Flawed Reactor Pressure Vessels in the Belgian NPPS Doel 3 and Tihange 2
Comments on the FANC Final Evaluation Report 2015

Ilse Tweer
Materials Scientist, Consultant

January 2016

Commissioned by the Greens/EFA Group in the European Parliament
Rue Wiertz
B-1047 Brussels

Figure 4.29

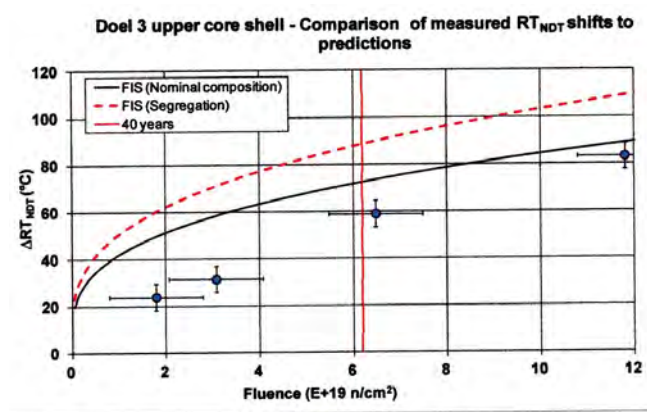
By definition a predictive trend curve is supposed to be the enveloping bound for all tested similar steels. All surveillance data (except the value for very high fluence) including the measuring scatter ranges are below the FIS curve as can be seen in the left diagram, below (figure 4.29, Electrabel Safety Case 2012, page 67.)

Figure 5.15: CHIVAS-10 results for D3 UCS and D3H1 compared to RPV Surveillance results and to RSE-M prediction.

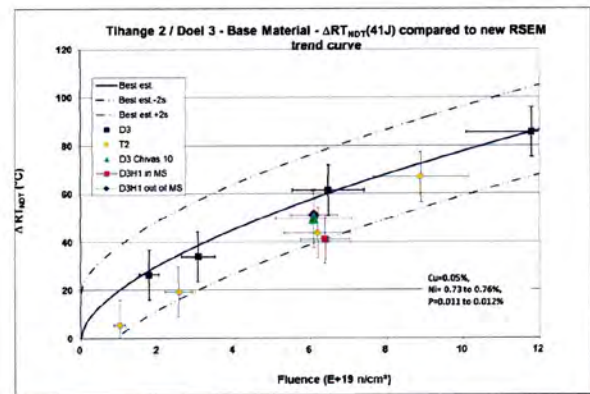
The new predictive curve designed by Electrabel is shown to fit the surveillance data from D3T2 “perfectly” can be seen in the right diagram below (Electrabel Safety Case 2015 figure 5.15, page 50), this figure shows that the experimental data and the scatter are not enveloped by the trend curve, the 2σ standard deviation is necessary for enveloping.

Remark: the experimental data differ in the figures from 2012 (FIS curve) and 2015 (the new trend curve): compare for instance the third D3 point from the left (in 2012 ΔRT_{NDT} is slightly below 60°C, in 2015 slightly above). Keeping in mind the experimental scatter, this difference is in fact negligible, but remarkable.

The inherent safety margin by using the FIS formula is completely lost by the use of the new Electrabel trend curves, because the deviation lines do not appear anymore in the curves to be used for SIA.

This demonstrates that new predictive trend curves are certainly not “very conservative”, they are fitted to the given D3T2 data. The additional shift of RT_{NDT} ($RT_{NDT,init,segr} + RT_{NDT,VB395} + M$) that is supposed to be a safety margin in the magnitude of the observed higher embrittlement in the VB395 samples seems to be designed in way that the limiting 132° for RT_{NDT} will not be reached before end of life.

Figure 11: Shift in RT_{NDT} ($\Delta T=41J$) versus fluence (LS = 'Less Segregated Zone', OF = 'out of flakes', BF = 'Between Flakes')

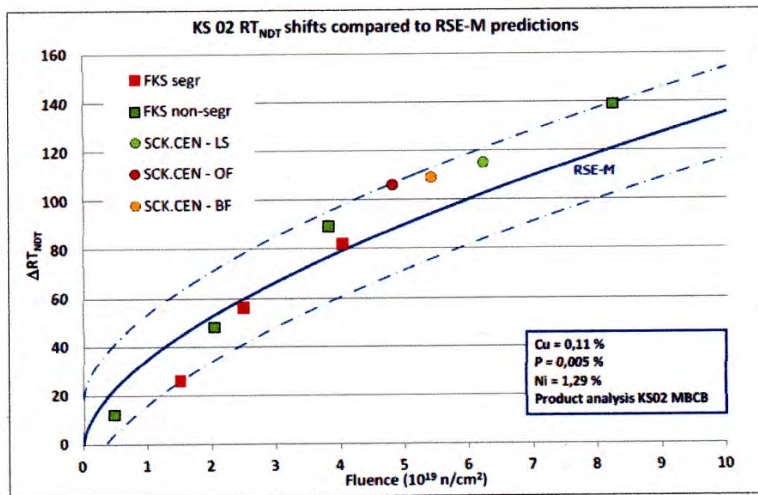
The RT_{NDT} shifts of the German RPV steel sample KS02 (as a comparable steel) should also be enveloped by the new predictive trend curve. The figure 11 in the SCP report on the Safety Case 2015 (page 21) shows that most of the experimental data points are above the curve.

The last irradiation campaign was performed with samples from a German hydrogen flakes containing similar steel (FKS: Forschungsvorhaben Komponentensicherheit) for further comparison. The measured RT_{NDT} shifts of this campaign also exceeded the trend curves by up to 20°C⁶³ (figure 11, page 21).

Figure 5.27: RT_{NDT} trend curves for the D3T2 core shells used in the SIA.

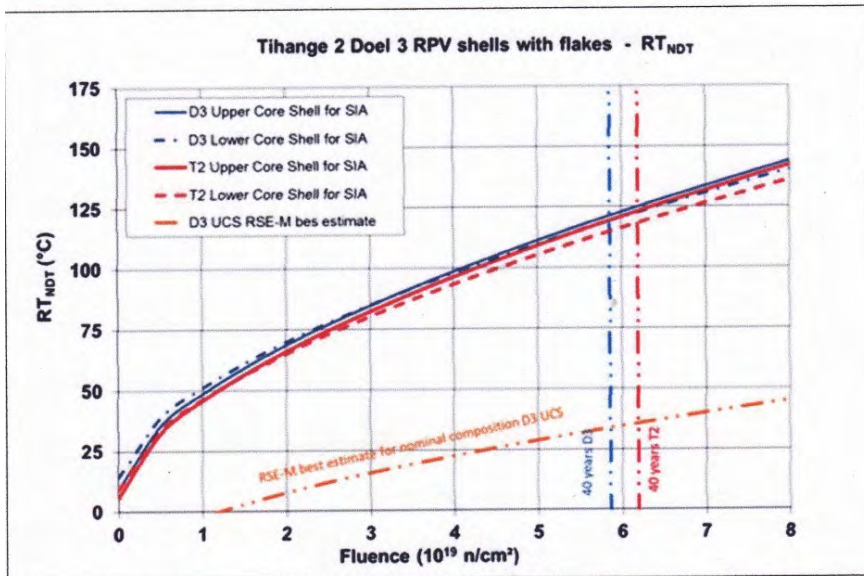
The figure 5.27 (page 71) in the Electrabel Safety Case 2015 allows the estimation of the used extra shift of RT_{NDT} supposed to be in the magnitude of the VB395 embrittlement at EOL: Assuming that the shift due to the FANC request is about 10°C, M about 15°C, the remaining difference is about 55-60°C. As derived in the preceding section the shift of the VB395 Master Curve is about 100°C. That means that the extra shift is de facto a random value, very probably fitted to the requirement that RT_{NDT} remains below 132°C until end-of-life. The figure shows that the trend curves to be used for SIA comply with this requirement.

- The safety margin “in the magnitude of the VB935 embrittlement” to be used for the structural integrity assessment is not quantified. The figures show that this extra margin might only be an adjustment to the requirement that RT_{NDT} has to remain below 132°C until end-of-life and by far smaller than the observed VB395 embrittlement.
